**TO:** Ryanne Sass, Plaza Street Partners  
**FROM:** Stacey Nerger, Senior Planner  
**DATE:** April 18, 2022  
**SUBJECT:** Lincoln Professional Park – Preliminary Site Plan  
Review Comments 03

# LINCOLN PROFESSIONAL PARK FILING NO.1 PRELIMINARY SITE PLAN

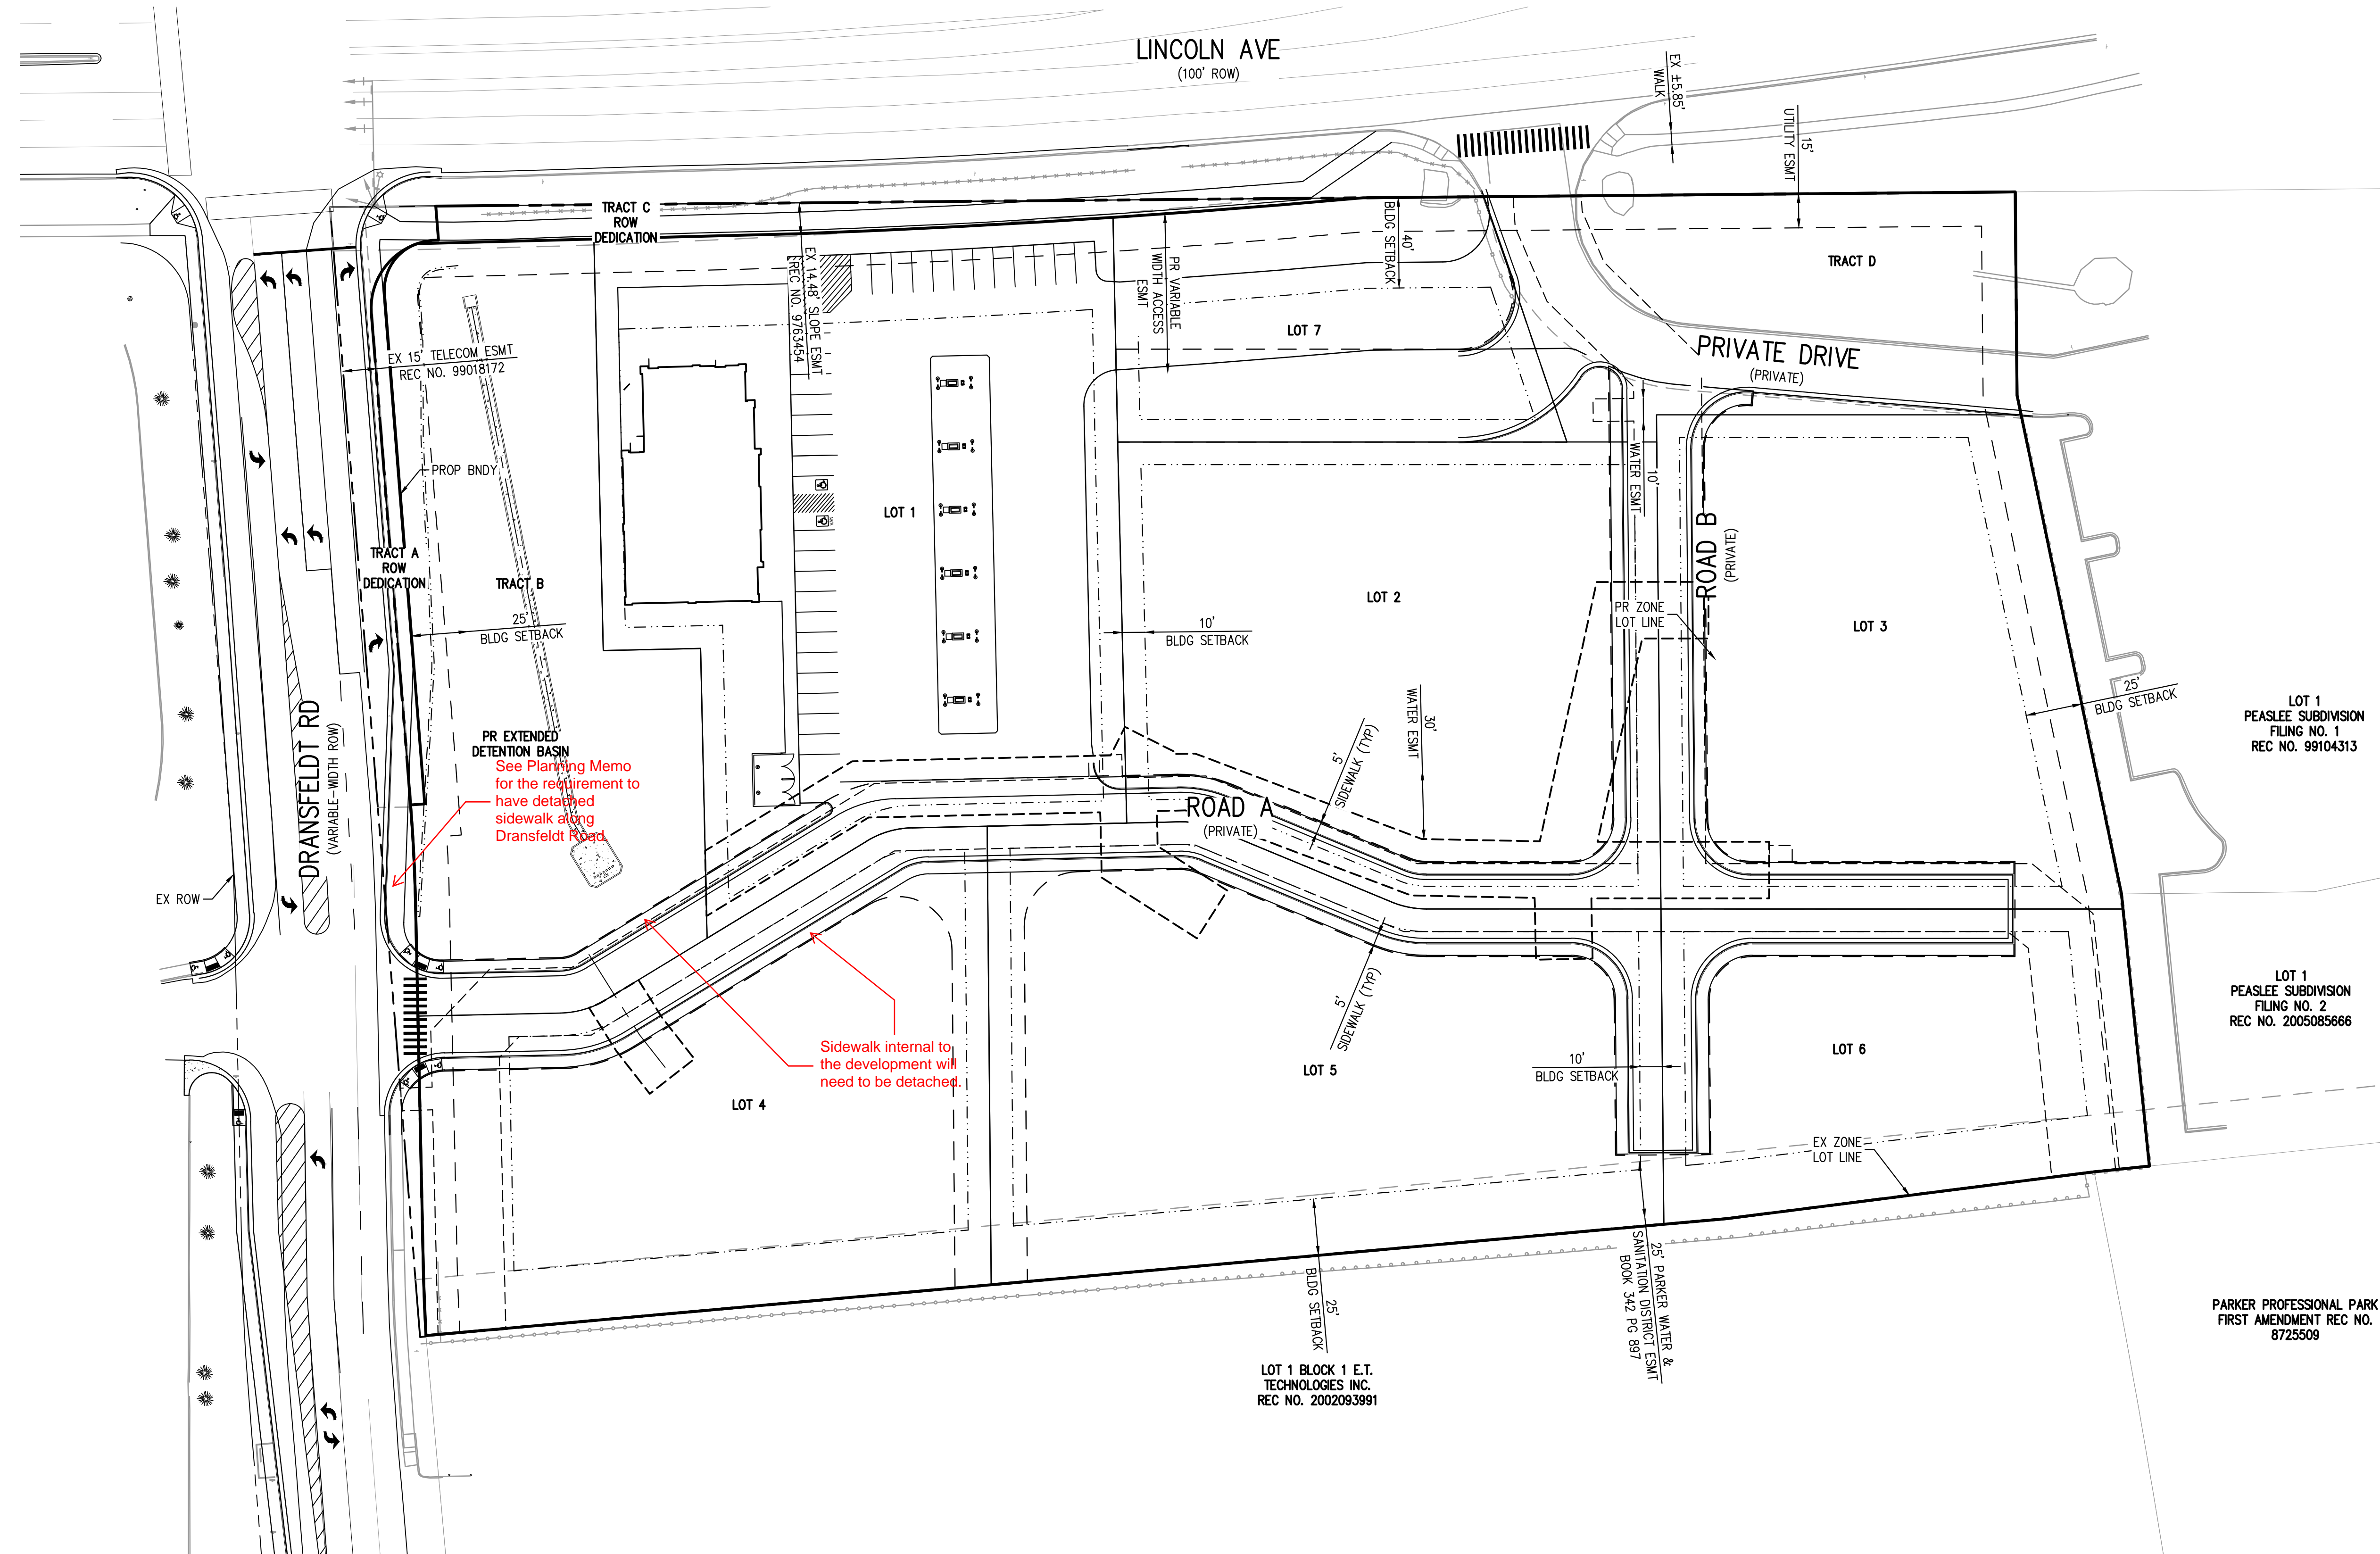
PR EXTENDED  
DETENTION BASIN  
See Planning Memo  
for the requirement to  
have detached  
sidewalk along  
Dransfeldt Road

Sidewalk internal to  
the development will  
need to be detached.

**Include this as part of the 4 sheet Preliminary Site Plan and add the title to the top.**

# LINCOLN PROFESSIONAL PARK FILING NO.1 PRELIMINARY SITE PLAN

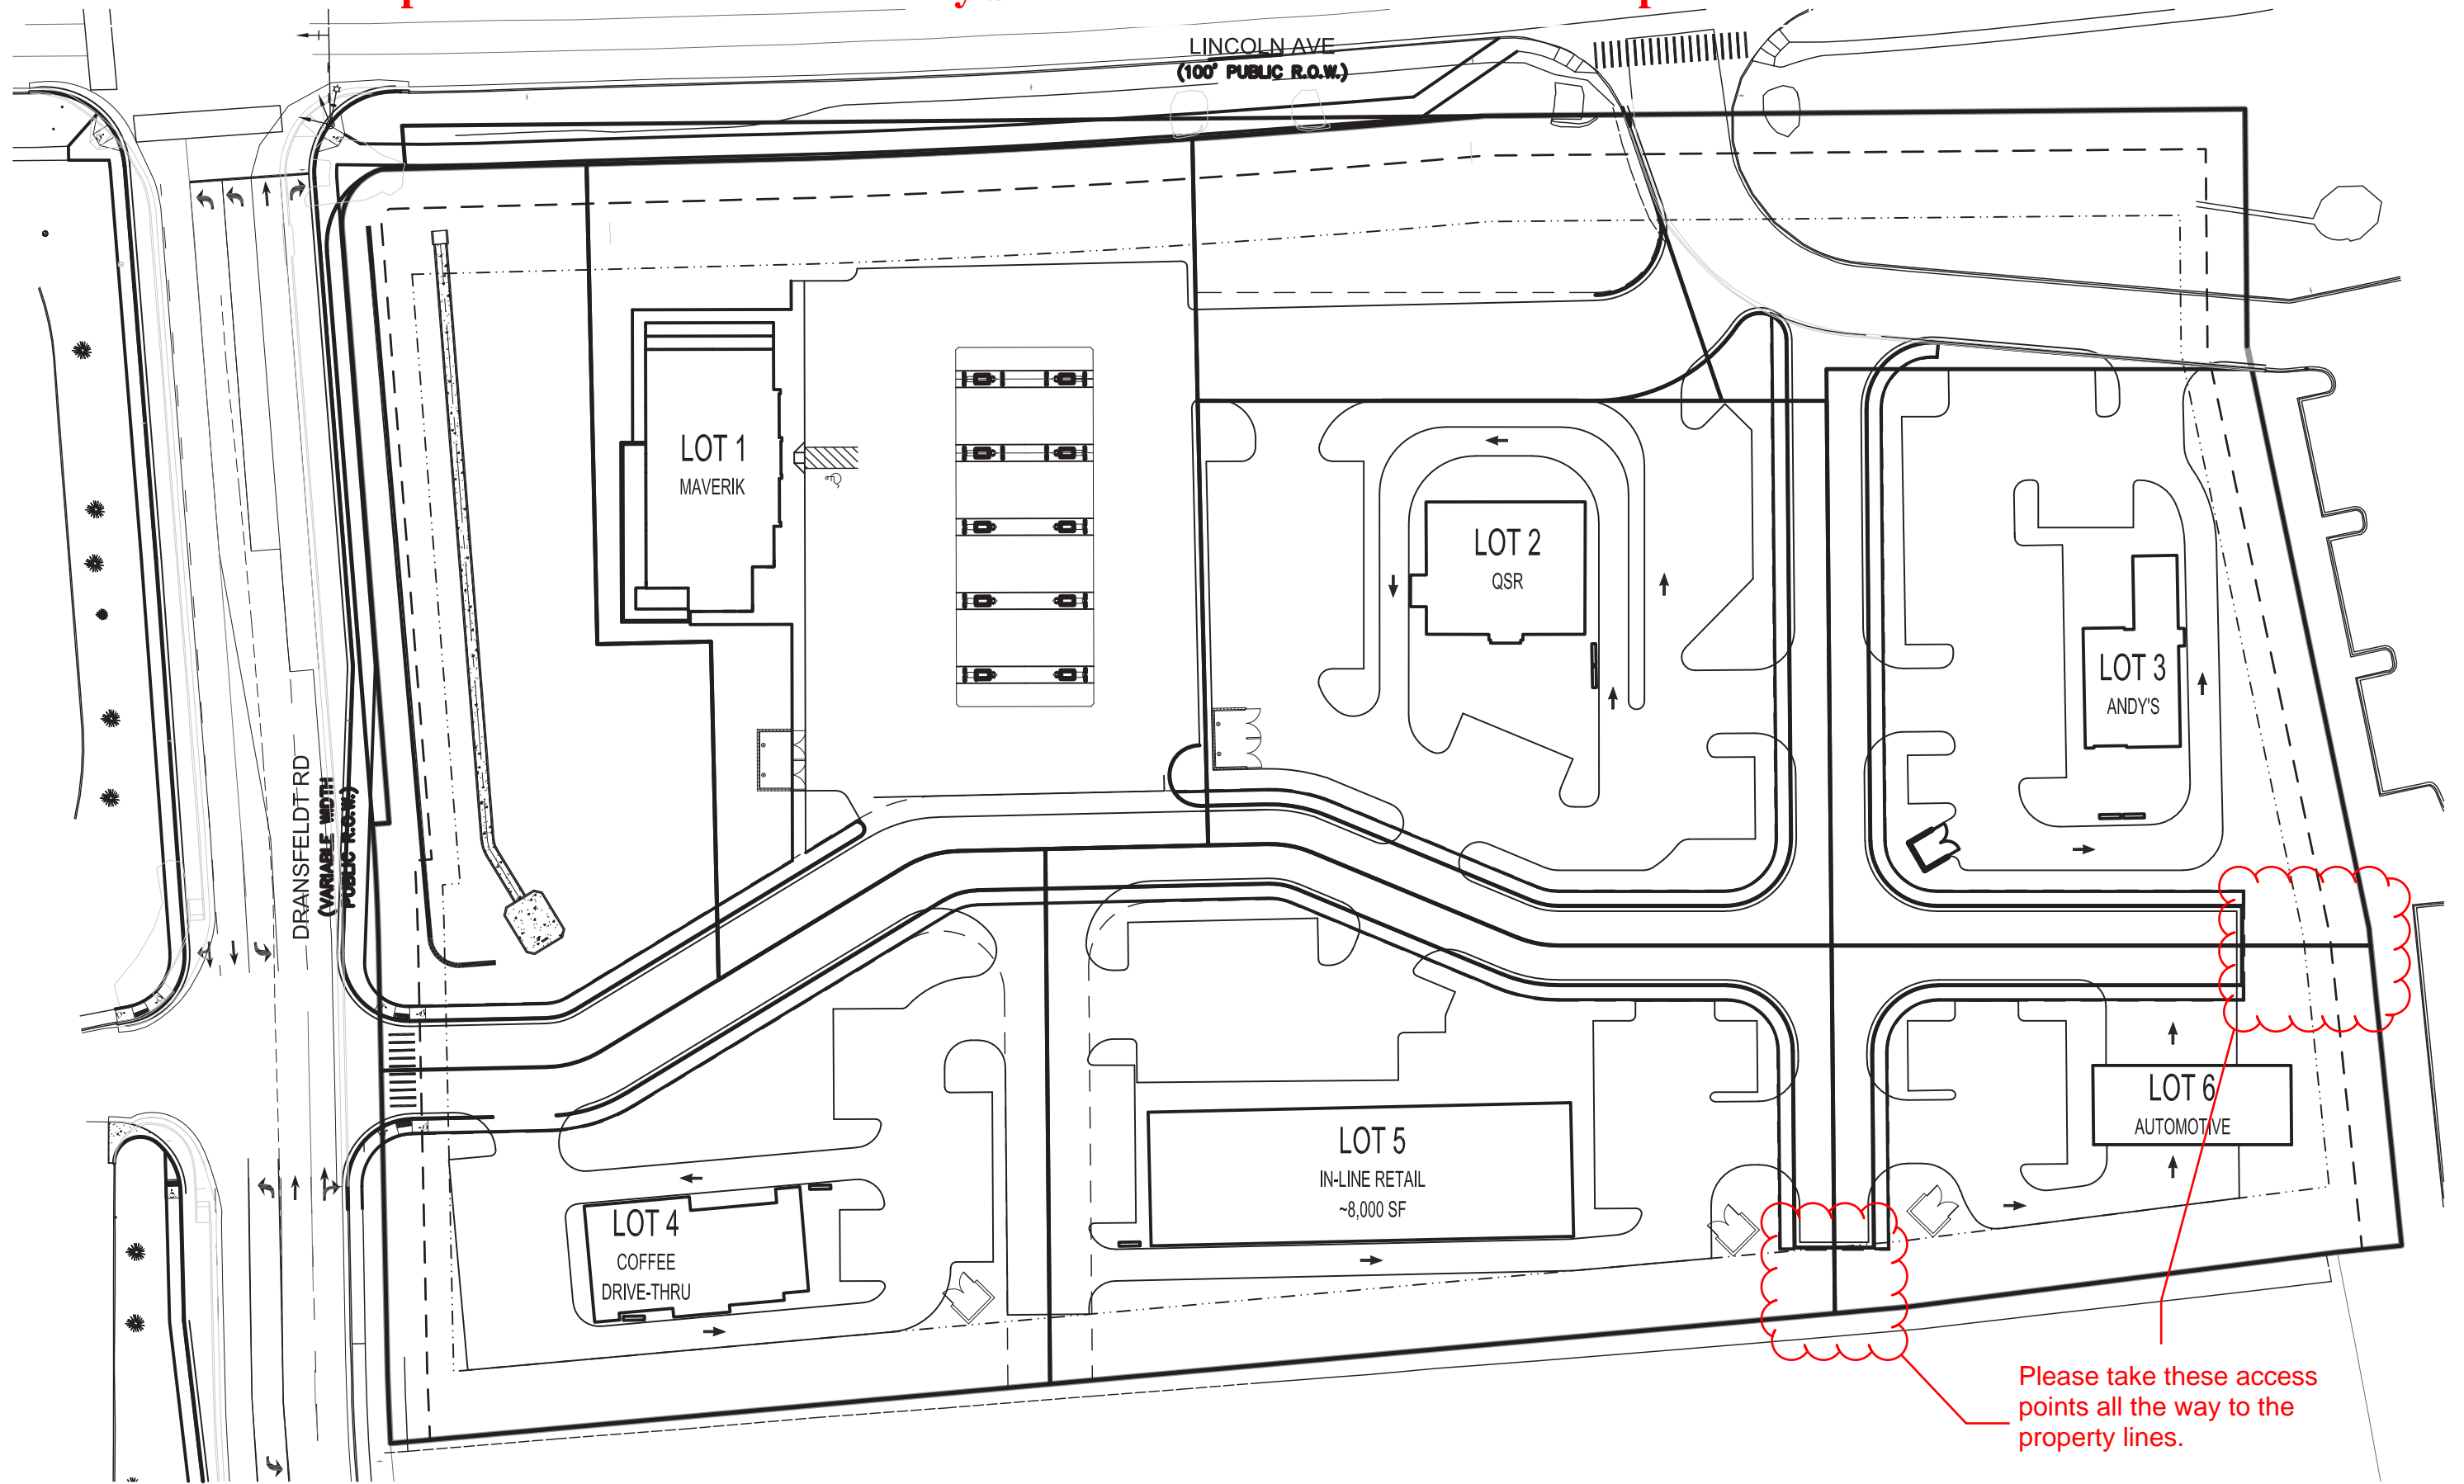
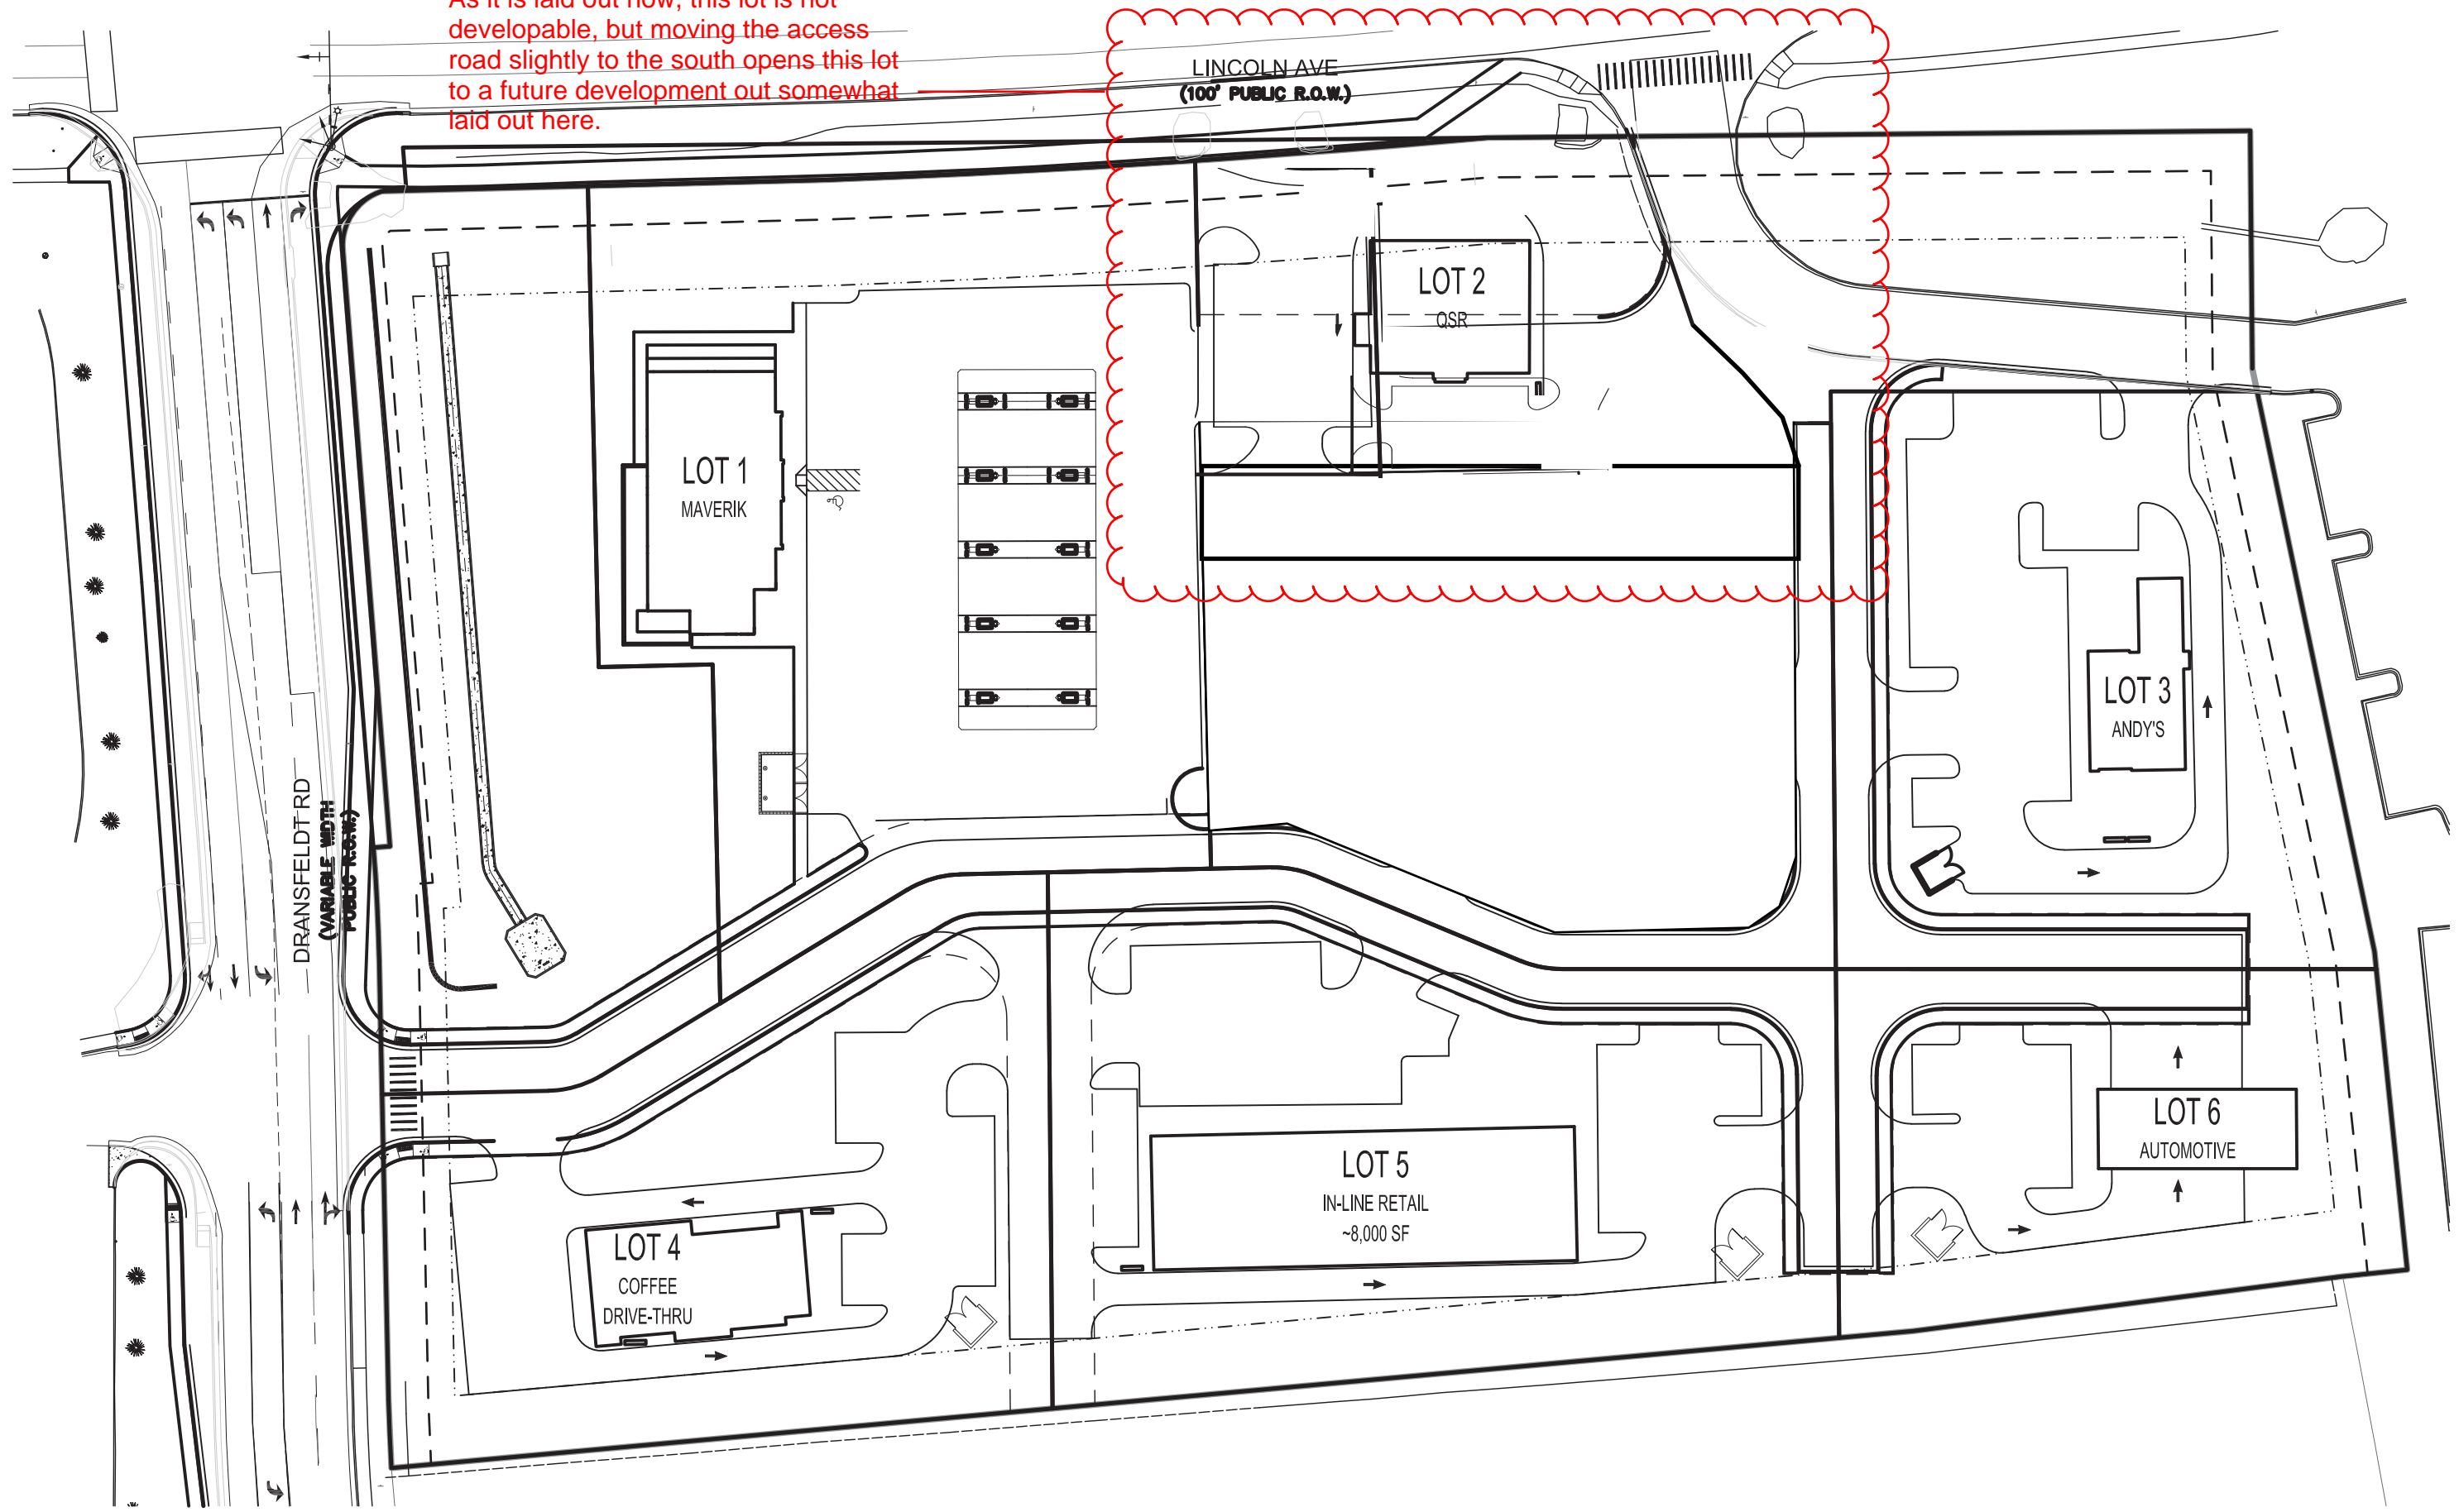
As it is laid out now, this lot is not developable, but moving the access road slightly to the south opens this lot to a future development out somewhat laid out here.

As stated in previous comments, per the Annexation Agreement, the Dransfeldt Road sidewalk is required to be detached with an 8 foot planting bed along the roadway and then a 5 foot sidewalk. Please amend the plans to show this. In addition, the sidewalk and landscaping should be part of the Minor Development Plat and can be copied from there.

The sidewalk internal to the site will also need to be detached with the tree lawn (streetscape) located adjacent to the roadway.

Break this down by the following:  
 Road Name  
 Dransfeldt Road  
 Lincoln Avenue  
 Internal North/South Road (or name of road)  
 Internal East/West Road (or name of road)
